# **HISTORIC PRESERVATION COMMISSION STAFF REPORT**

**APPLICATION:** CA2018-02

**TITLE:** Certificate of Appropriateness CA2018-02; HL-143/MA-133  
228 West Olive Avenue

**REQUEST:** Review the replacement of two non-period window surrounds on the east (side) building elevation. Review the restoration of the front porch, including removal of the concrete floor and restoration of Douglas fir planking, repair of rotted support posts, and repair of the sagging roofline.

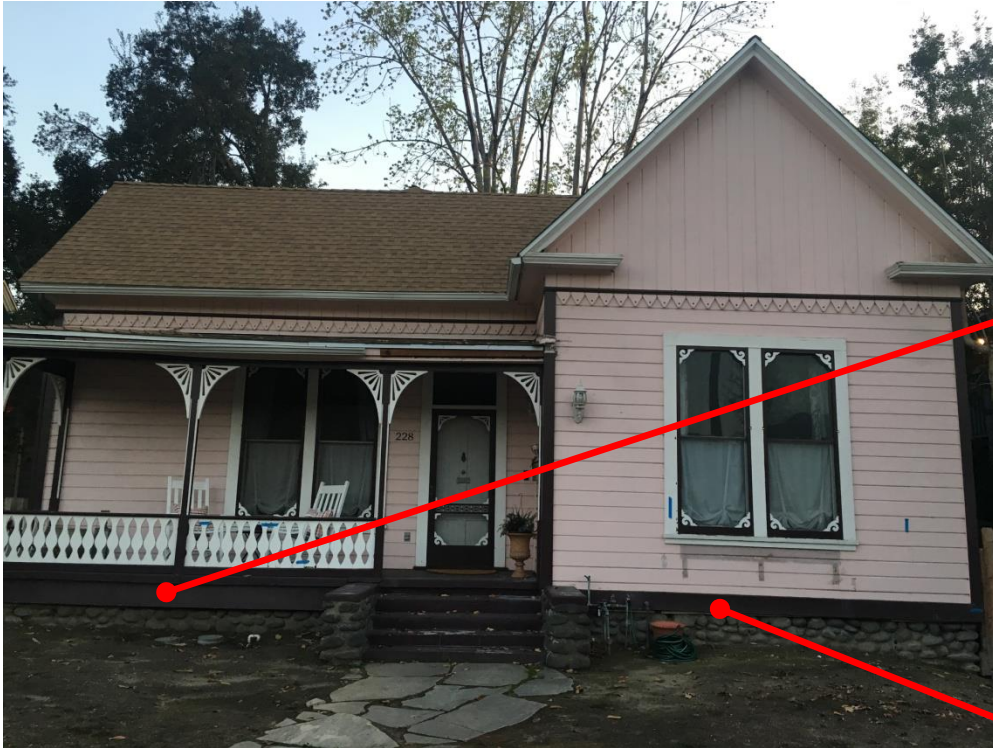
**4.b. Restoration—Porch Ceiling.** Replace incorrect porch ceiling planks (white) with in-kind planks matching original planks (pink). White planks are Home Depot-like patches that do not match original wood ceiling. End goal is to have ceiling look similar to historical Andersen House on Lime Street (right).
